Amendment to the Drawings

Remarks

This is responsive to the Office Action mailed December 7, 2005. The amendments and remarks herein are proper, are supported by the specification, and do not include new matter.

FIG. 15

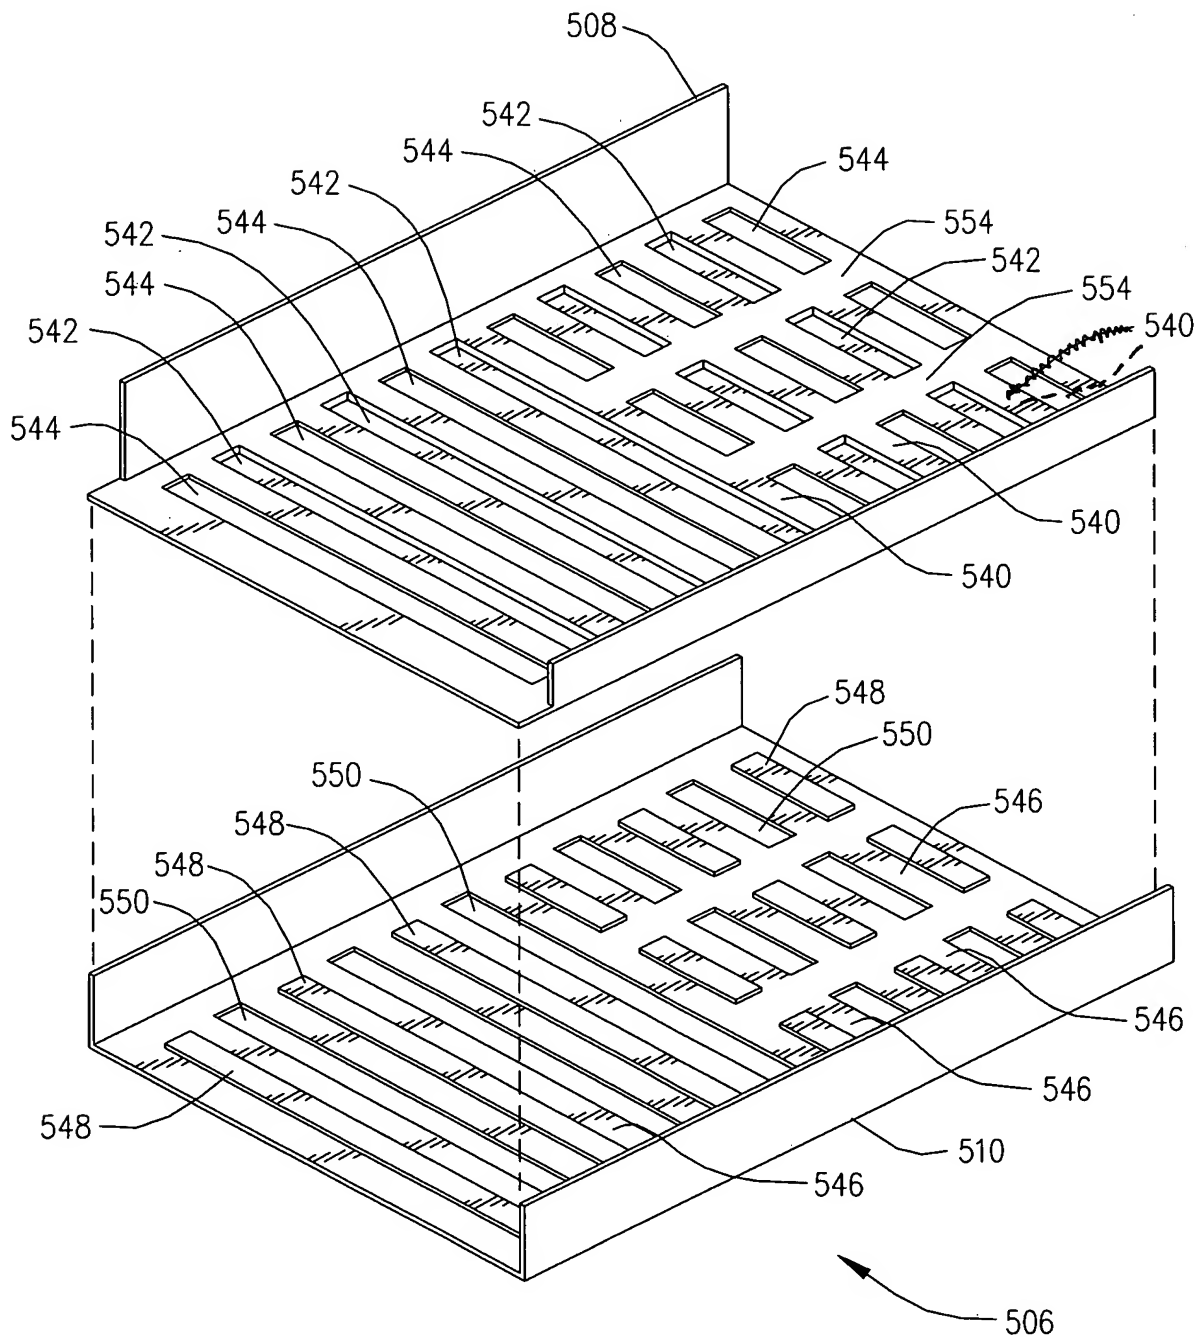
The attached sheet of drawings includes an amendment to FIG. 15. FIG. 15 has been amended to make the lead line for item 540, planar surface, a hidden lead line because the planar surface 540 is hidden in this isometric view.
